Dear reviewer, dear Jim,

Thank you for your constructive feedback. We have worked on the two main comments you have pointed out. Our response is listed in blue.

The authors present a well-crafted, well-written investigation of recent changes to two fans of the Himalayan Terai region, with specific focus on the evolution of the Karnali River from a two-branch to a single-branch system. The topic is of considerable interest, and the manuscript is in pretty good shape – I found only a very few minor issues to comment on throughout.

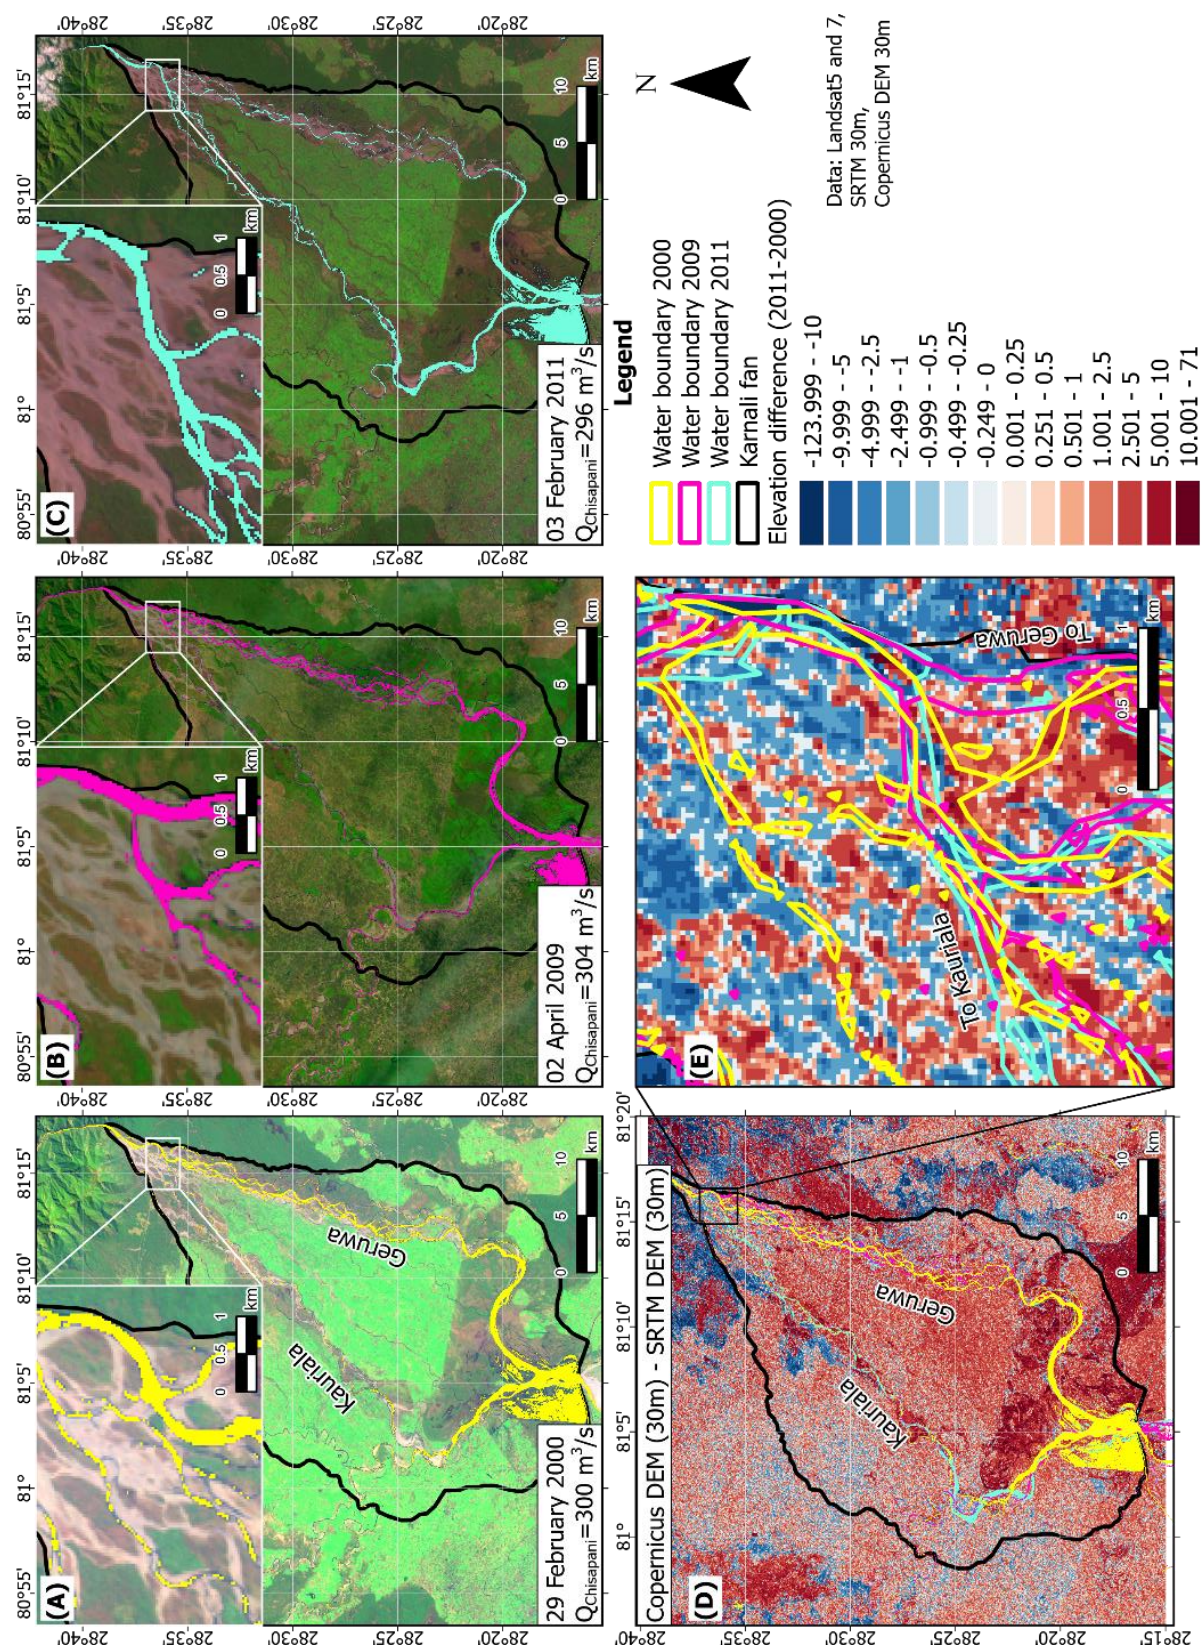
On the second point: the only real support available that I could discern for the idea that one of the channels was “plugged” by coarse bed material in 2009 is the large grain size at the outside of a bend near the head of the fan. This seems like minimal support to me: ideally some evidence of the deposit itself might be available, or some other supporting evidence. I would like the authors to either more clearly summarize the existing evidence (in case I have missed something), and then discuss additional evidence would could (should?) be collected before accepting this working hypothesis (e.g., before and after topographic surveys, field mapping of the coarse deposit from 2009, and so on). This discussion would strengthen the scientific impact of the author’s work.

**Comment 7.** Line 208. The hypothesis to be tested should be presented in the introduction, and specific methods available to test it should be outlined in the methods. Evidence from grain size only is somewhat weak, it seems to me. Is the hypothesis supported by topography analyses, or are these data insufficient or unavailable?

Following your question, we have investigated remotely sensed data of the area in more detail. We have analyzed satellite images and global DEM data sets from before and after 2009. We have considered SRTM 30m Global DEM data, which represents earth surface elevation from 2000, as well as the composite Copernicus 30m Global DEM collected over the period 2011-2013. Most of the Copernicus data for the Karnali fluvial fan stems from 2011. These two DEM data sets are the only ones available to us.

In addition to DEM data, we have analyzed Landsat images from 2000, 2009 (before the monsoon season), and 2011 to extract land cover and stream network information, both under low discharge conditions at Chisapani (Figure 1).

In 2000, the Geruwa branch carried a significant portion of the water discharge, and under low flow conditions at least two channels supplied water to the eastern Geruwa branch from an outer bend at Dolphin Point in the upstream Karnali River (Figure 1A). By 2009 (yet before the double monsoon peak), a new eastern channel has formed near the eastern fan boundary (Figure 1B). In 2011, this eastern channel supplying water to the Geruwa branch ceased to exist (Figure 1C). Under low flow conditions, only one channel still supplies water to the Geruwa branch, and it has narrowed since

The disappearance and decline of the eastern channels between 2009 and 2011 reflect the decline of river discharge into the Geruwa branch, which seems to be associated with sediment deposition in the channel taking off from the outer bend at Dolphin point.

We have computed the difference in surface elevation between the composite Copernicus DEM (2011-2013) and the SRTM DEM (2000) (Figure 1D-E). In 2011 the upstream zone of the Geruwa branch has become elevated compared to 2000 (Figure 1E). Our domain of interest is unvegetated, which implies that DEM surface elevation data reflecting canopy elevation for vegetated areas does not affect estimates. Sediment deposition between 2011-2013 and 2000 and the resulting elevation difference across the upstream region of the Geruwa branch seem to have restricted the water discharge into the Geruwa branch.

Figure 2: Grain size distributions of the surface sediment obtained from image analysis at various locations across the Karnali fluvial fan. Only grains with a major axis length larger than 20mm could be distinguished.

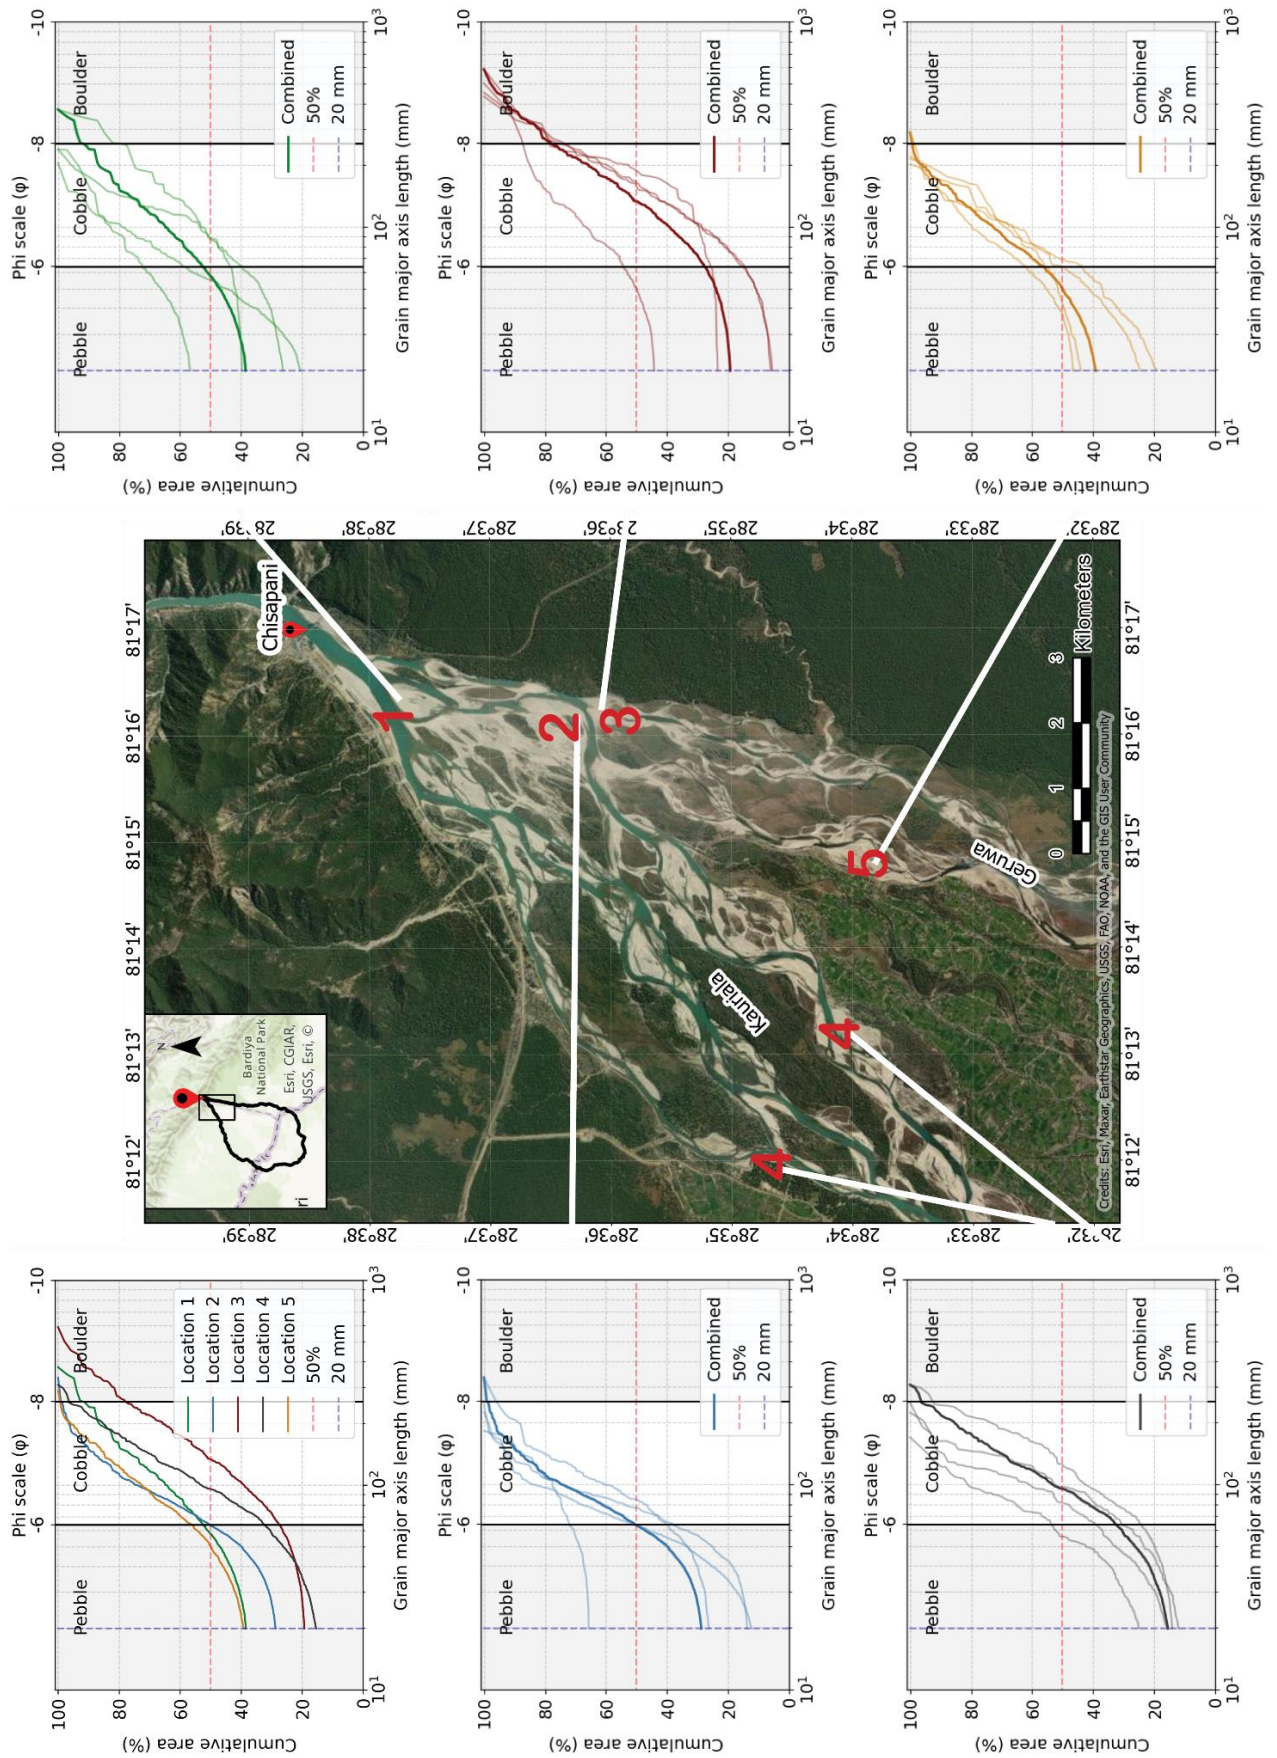
**Comment 8.** Line 215. But little direct evidence besides grain size has been presented for this. I think it remains a "working hypothesis", rather than a "finding". This may be semantics, but nonetheless important.

In addition, we have analyzed grain size distributions of the bed surface sediment. To this end, we have determined surface grain-size distributions from images taken at various locations along the fluvial fan (Figure 2). We have used Segmenteverygrain (Sylvester et al., 2025), a python-based tool, to determine surface sediment grain size from the images. The results indicate that the surface sediment across the outer bend at Dolphin Point and the upper reach of the Geruwa branch consists of a large amount of boulders compared to other locations.

The increase in bed level and boulder deposition across the upstream end of the Geruwa branch underline our hypothesis that a self-reinforcing mechanism was triggered (a) where boulders carried during peak flood discharge are deposited right downstream of the Karnali outer bend across the upstream end of the Geruwa branch; (b) deposited boulders, unable to move further downstream under these peak discharges, increase riverbed level across the upstream Geruwa branch, (c) this subsequently reduces the flow entering this branch; (d) this reduced flow limits the further transport of boulders into the Geruwa branch and (e) enhances further boulder deposition in the subsequent flood season.
